Milldale Fast Track – Specialists Comments – 23/05/2025

20/05, 23/05 – Updated / new comments

28/05 – Updated / new comments

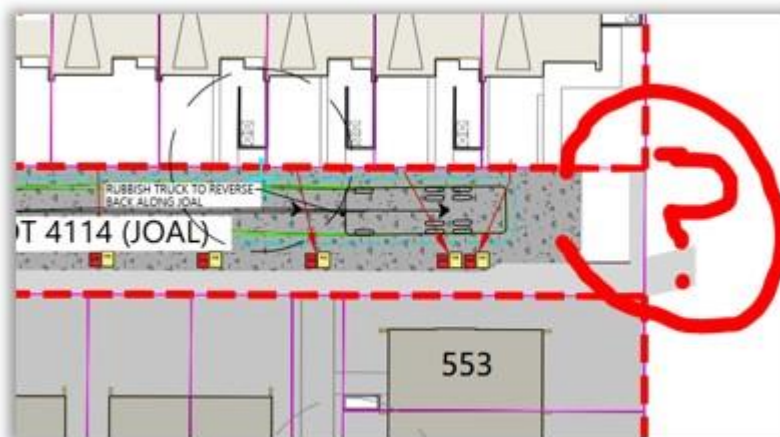
<ul style="list-style-type: none">• Stage 4C. Consistent through all Stage 4C substages. As per AEE, waste collection is proposed via council service however as far as I'm aware council trucks do not go into private property i.e. JOALs. Proposal is for bins to be placed on only one side of JOAL? – do homeowners know this? What if they don't? Is the bin space reserved for bins? No manoeuvring space and end of JOAL's = truck has to reverse. Waste Management team to confirm. As per below:		
--	--	--	--	--	--

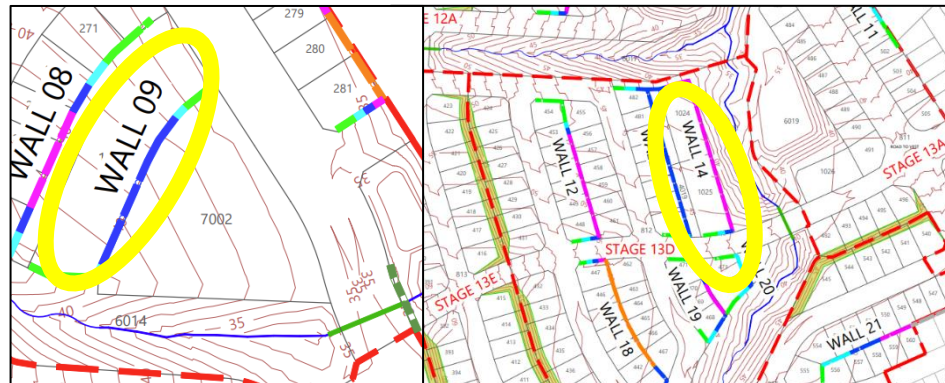
while also providing privacy and safety. This results in a combined structure potentially reaching a height of 3.2 metres. However, the applicant's own design guidelines and landscape plans do not clearly demonstrate how the visual impact of these combined elements will be mitigated, and no landscaping treatment has been identified. The neighbourhood park is located to the south-east of the superlot where shadowing may affect the public space. Concerns for passive surveillance and CPTED outcomes remain.

Drainage Reserve - Activation Areas*

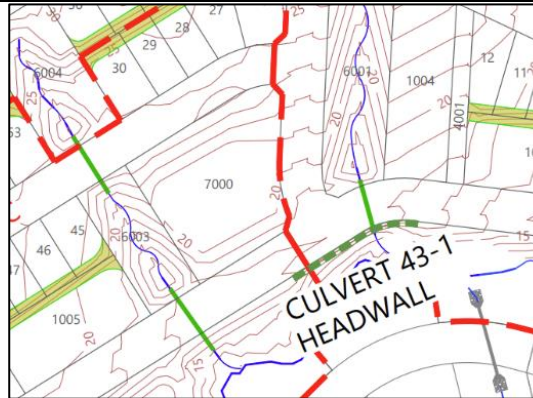
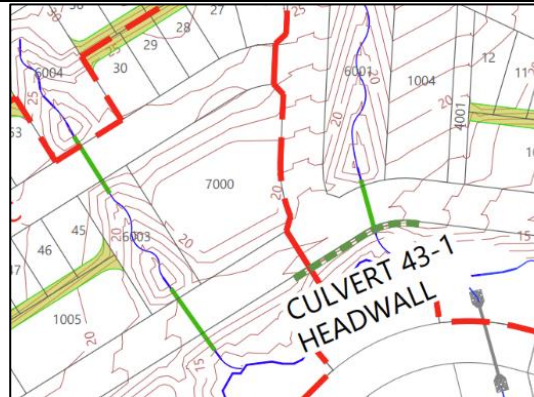
- The number of bridge connections could raise concerns from an operations and maintenance view. Bridges are likely to require local board approval and will generally not be supported. It also raises activation and asset management concerns for the drainage reserve areas. These are likely to require reconfiguration at EPA and detailed design to avoid bridge structures. The focus will rather be on pathway connections in the overall design.

Extract of settlement monitoring plan from Geotech report – notice the difference in contours

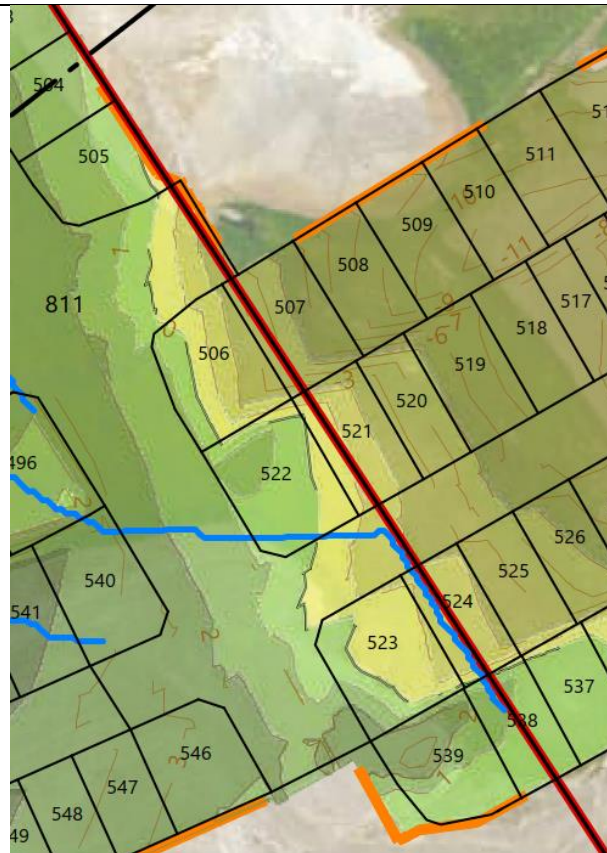
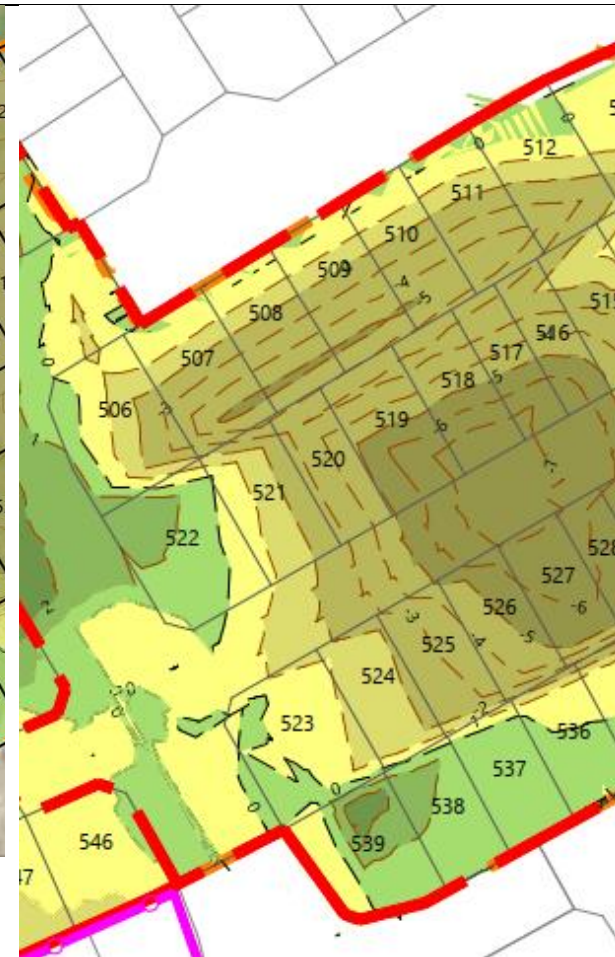
under E7 rules. I consider they need both, and assume the omission in the AEE is an error, given the references made in the Overview Report. Could this please be checked with the applicant._	consents and additional assessment will be provided	
23/05	Luke Xu	Geotech	<p><u>23/05 Initial comments:</u> <u>Stage 10-13:</u></p> <p>1. Time to achieve estimated t90 settlement not stated, though this is partially addressed in the settlement memo where it stated previous stages observed time to t90 around 9 months to 1 year. We suggest that this be confirmed to aid in managing and controlling the effects of earthworks causing subsidence/instability onsite and ensure safe building platforms are achieved before 224(c) is issued following objectives and policies under E38 subdivision. We are agreeable that a settlement monitoring plan is required. Note that the earthworks plan relied upon for the settlement monitoring plan in the Geotechnical Report does not align with the plan supplied by Milldale (drawings : P24-128-00-1202-EW and P24-128-00-1203-EW), a finalised settlement monitoring plan should be submitted.</p>

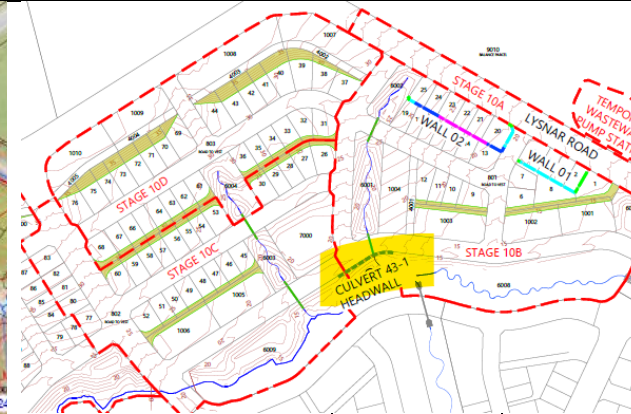
4. There is discrepancy in the retaining wall plan where Woods Development does not show the full extent of the retaining wall in the Stage 10-11 works area where CMW considered it to be necessary and have modelled this in their slope stability outputs.

SHEET 1202-EW

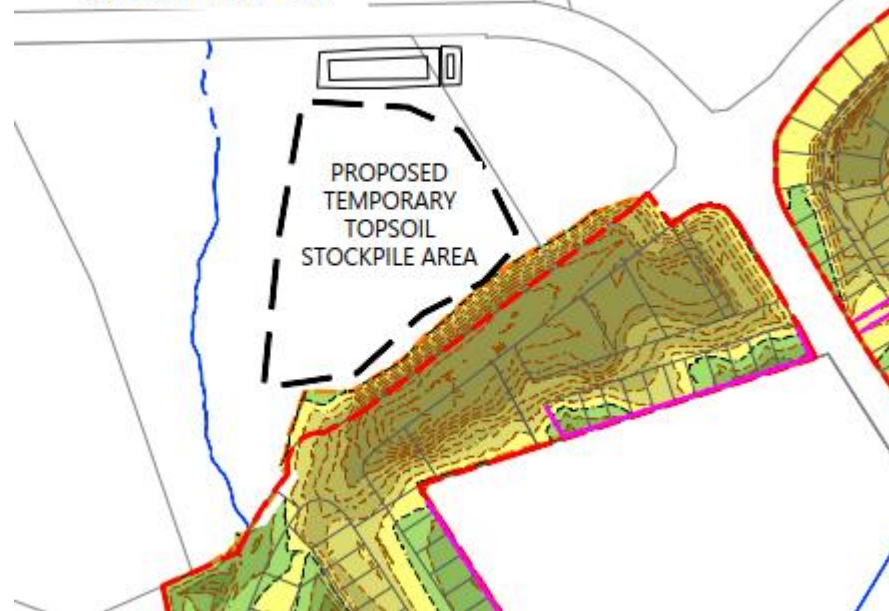
5. No cross sections or slope stability analyses are provided along the existing overland flow path where the softened alluvium material is expected to be the deepest. Further, the proposed stockpile area located above a gully feature and overland flow path (north of stage 12) may pose a risk of instability and the only reference in the reporting is for the locations to be approved by a geotechnical engineer prior to placement. We suggest that this be provided for review or an annotation provided on the plans to reinforce that its location is subject to geotechnical endorsement.

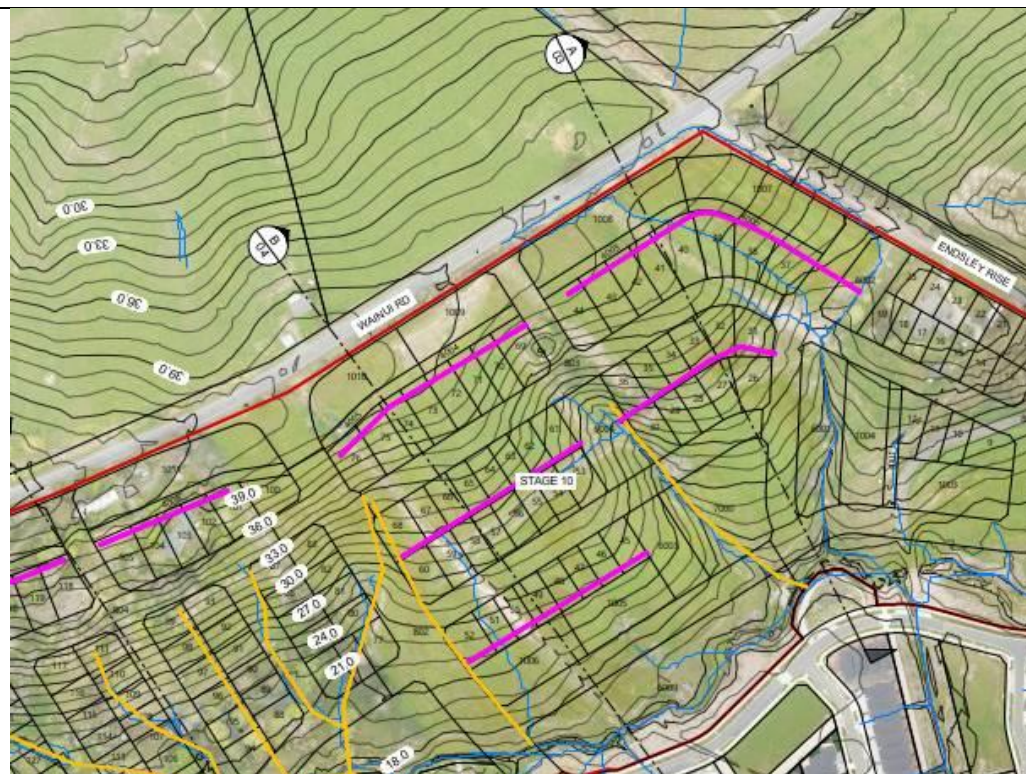
<p>11. Appendix F, Figure 3 of the slope stability assessment omits remediation outputs for Section A, which was identified as requiring remediation ‘retaining wall with palisade action’ in Section 5.</p> <p>12. Adopted parameters for the modelled retaining structures on the SLIDE outputs not shown e.g., Section A – Proposed with remediation (Retaining Walls), Section K- Proposed with Remediation (Shear Key and Retaining Wall).</p> <p>13. It is noted that restrictions are expected to be applied above and below the reinforced earth batters (from Section 8), an indicative plan should be provided to show the locations of development restriction zones as this may impact Lot placement and development yield.</p> <p>14. Reinforced slopes shown in the Milldale plans (e.g., P24-128-00-0013-SU) are not clearly shown in the remedial slope stability analyses e.g., Cross Section A and B etc. Are reinforced slopes still required in these areas or just drainage? We also note that Sections A and B has been excluded from drawing 25 by CMW for reinforced earth batter slopes. This creates inconsistency, may alter the ground profile and development restriction zones.</p>
